**Re: Letter of Notification of Duquesne Light Company for Approval to Reconfigure Existing and Construct New 138 kV Transmission Lines in Allegheny County, Pennsylvania
Docket No. A-2018-3002896**

**Bureau of Technical Utility Services
Data Requests to Duquesne Light Company**

Docket No. A-2018-3002896

REVISED
ATTACHMENT 3

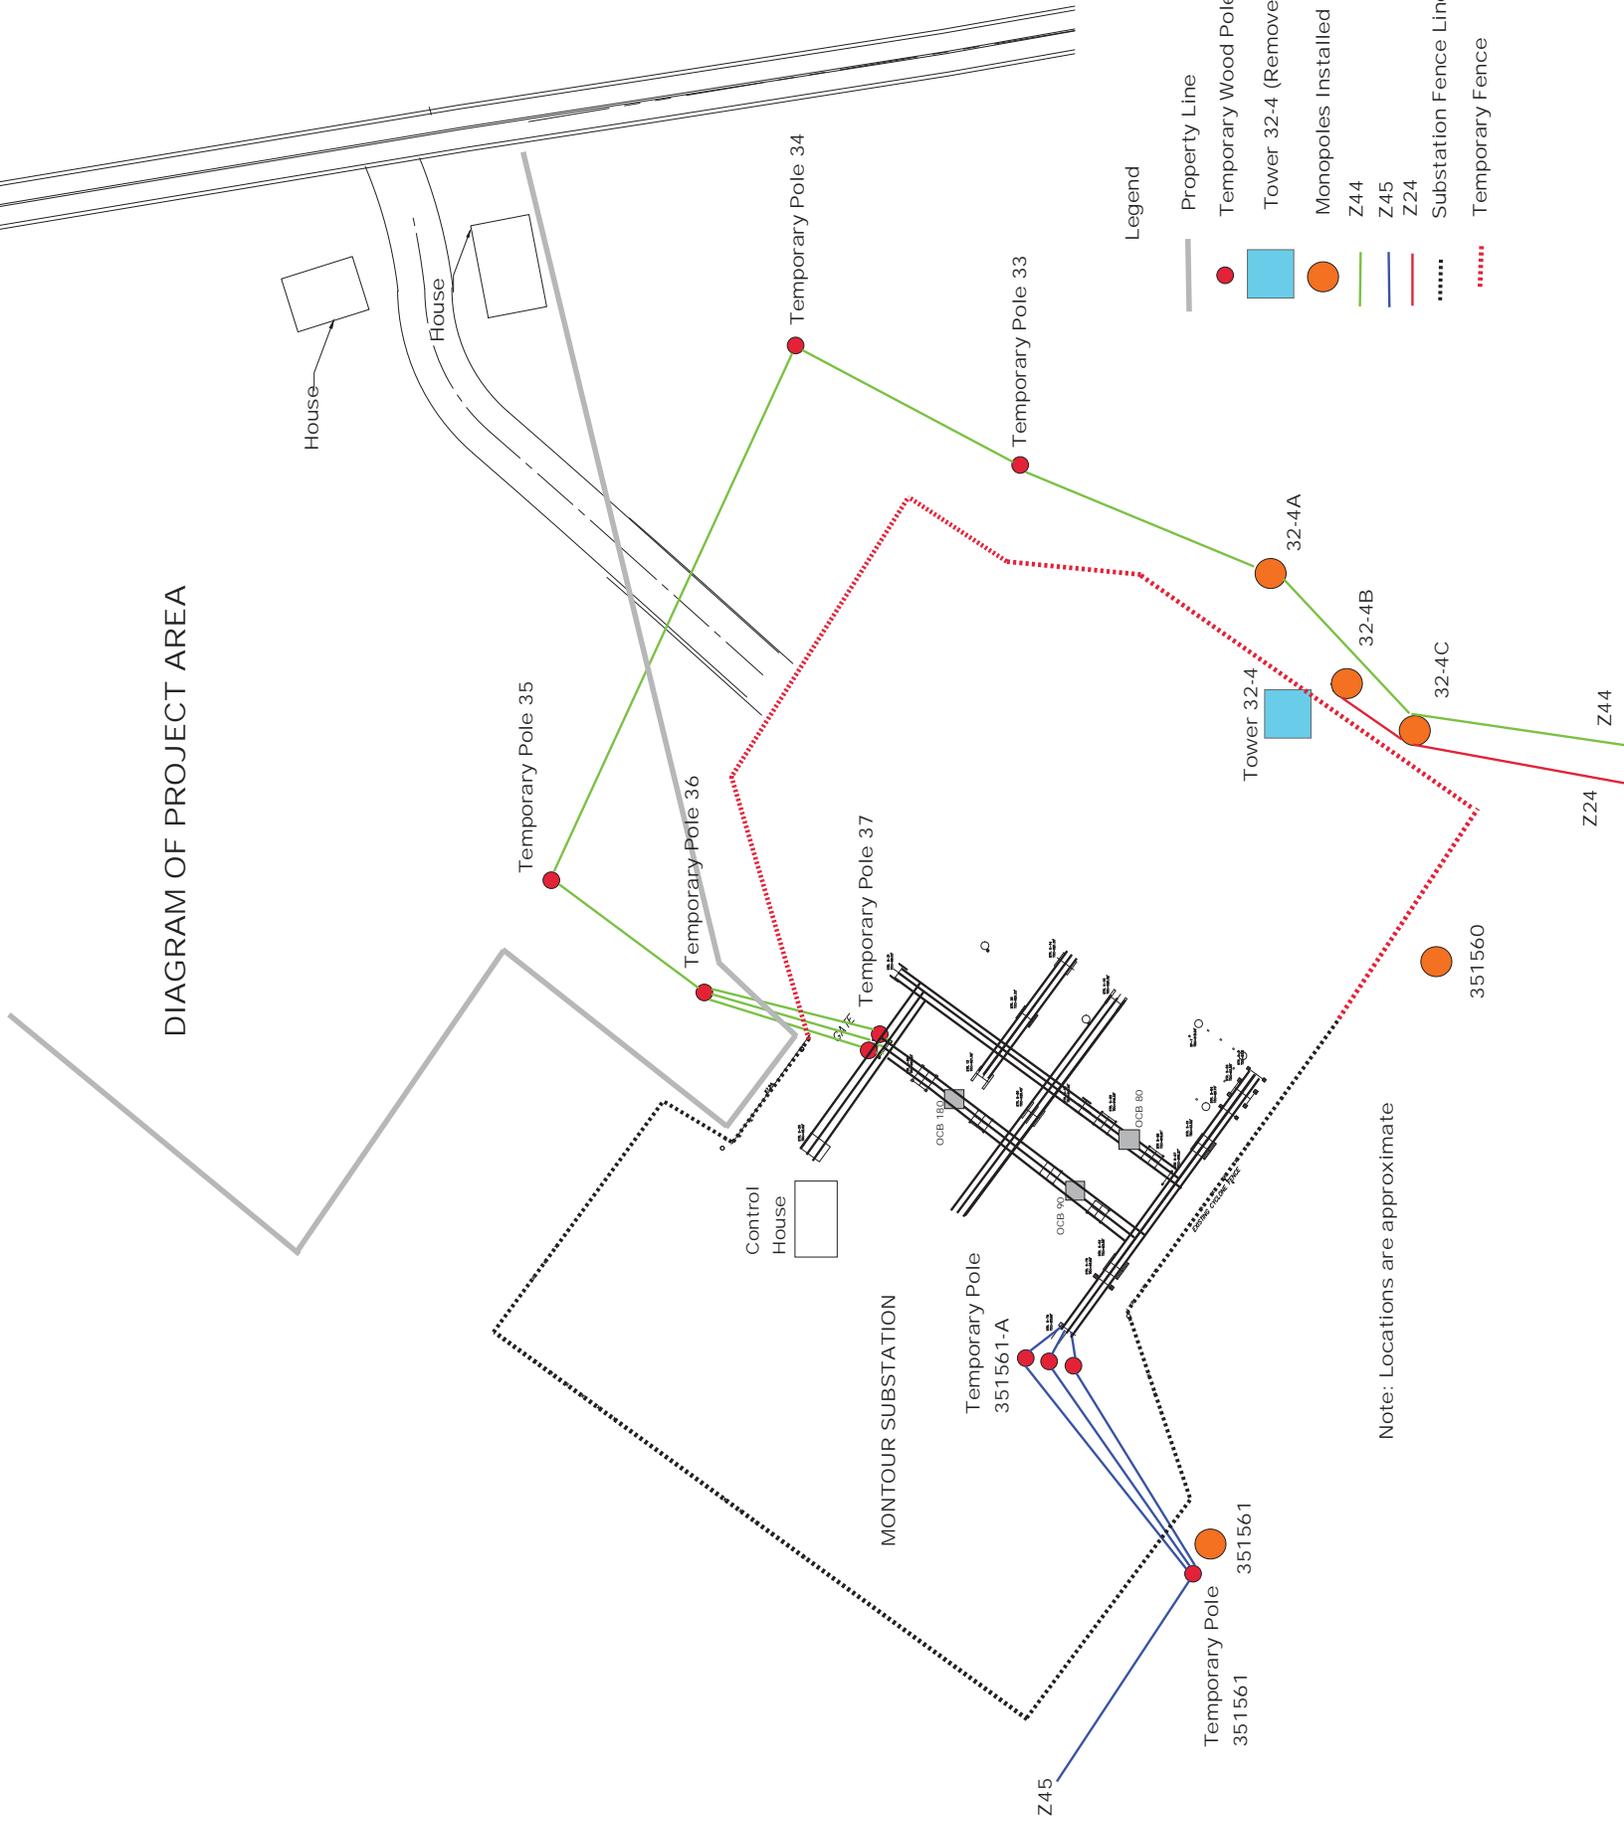
A-6 Reference the Letter of Notification, Section III(B). Please state the height of the new temporary and permanent transmission line structures to be installed.

The following temporary transmission line structures will be installed as part of the proposed project. Included in this response is a revised Attachment 3, which more clearly identifies the temporary transmission structures.

Temporary Transmission Line Wood Poles	Proposed Height of Wood Poles
351561 Temp	85 ft
351561-A Temp (3-wood pole structure)	60 ft /50 ft /60 ft
33 Temp	66 ft
34 Temp	70 ft
35 Temp	75 ft
36 Temp	61 ft
37 Temp (2-wood pole structure)	52 ft
